#### APPLICATION FOR A CERTIFICATE OF APPROPRIATENESS – STAFF REPORT

COA-0027-2020 219 NORTH EAST STREET

Nature of Project: Construct addition

Architect
Ashley Henkel Morris
306 Pell Street
Raleigh, NC 27604
919.696.0970 219 East St - New Rear Elevation

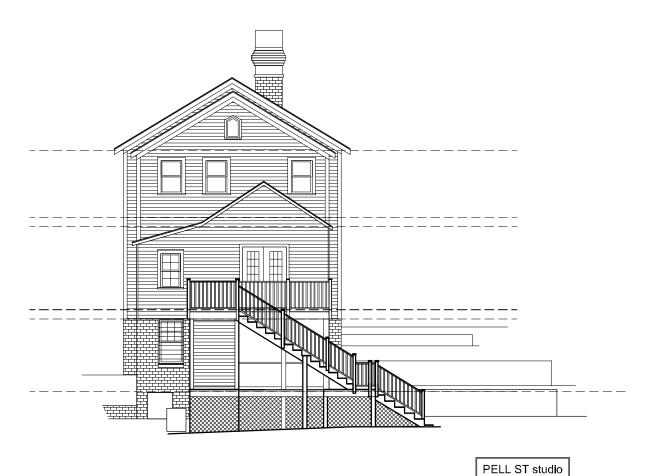
- 7\* A single pointed-arch window located high in the exposed gable end of the new rear addition is not addressed outside of the new rear elevation drawing. The new window appears to be similar in configuration and position to an existing pointed-arch window on the existing rear elevation that will be obscured by the new addition. Specifications and section drawings were not provided.

- 1. That details and specifications for the following be provided to and approved by staff prior
  - to installation or construction:
    - a. Window specifications and section drawings for the single arched window
    - b. Eave and soffit details
    - c. Roofing sample, if not matching existing color;
    - d. Paint color samples from the manufacturer if different than the existing house;
    - e. Gutters and downspouts location on the building;
    - f. Exterior lighting including location on the building, if any.
